HOSHIZAKI AMERICA, INC.

SERVICE BULLETIN

SB16-0002R1

Subject: New replacement board 2A8054-01 will replace 2A4296-01, 2A4296-02 and 2A8053-01

2A8054-01 Printed on board between
relays and K2 connector

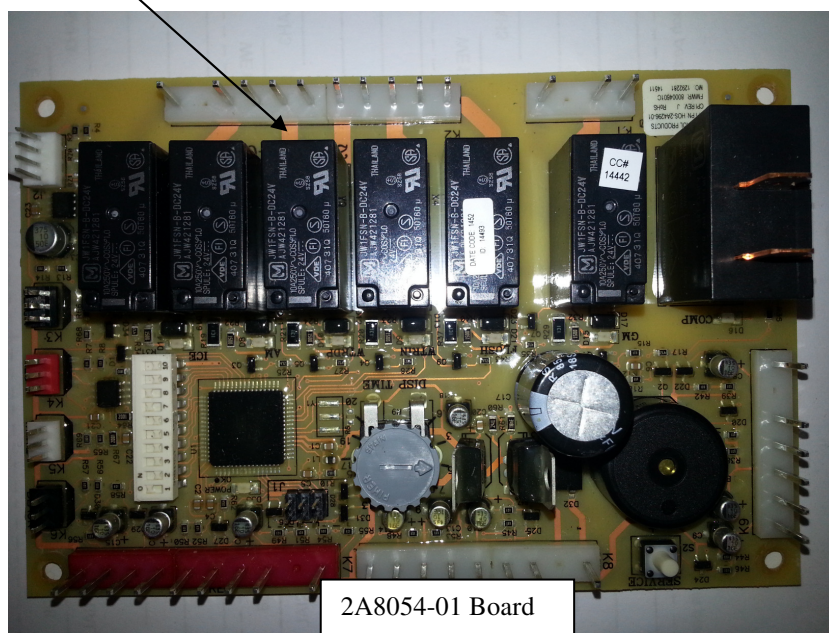
The 2A8054-01 has been developed and is a universal replacement for Flaker/DCM control boards 2A4296-01, 2A4296-02 and 2A8053-01. Note: Dipswitch settings may be different with 2A8054-01 from previous boards.

This is not a replacement board for units built with control board 437305-01 or 4A5591-01.
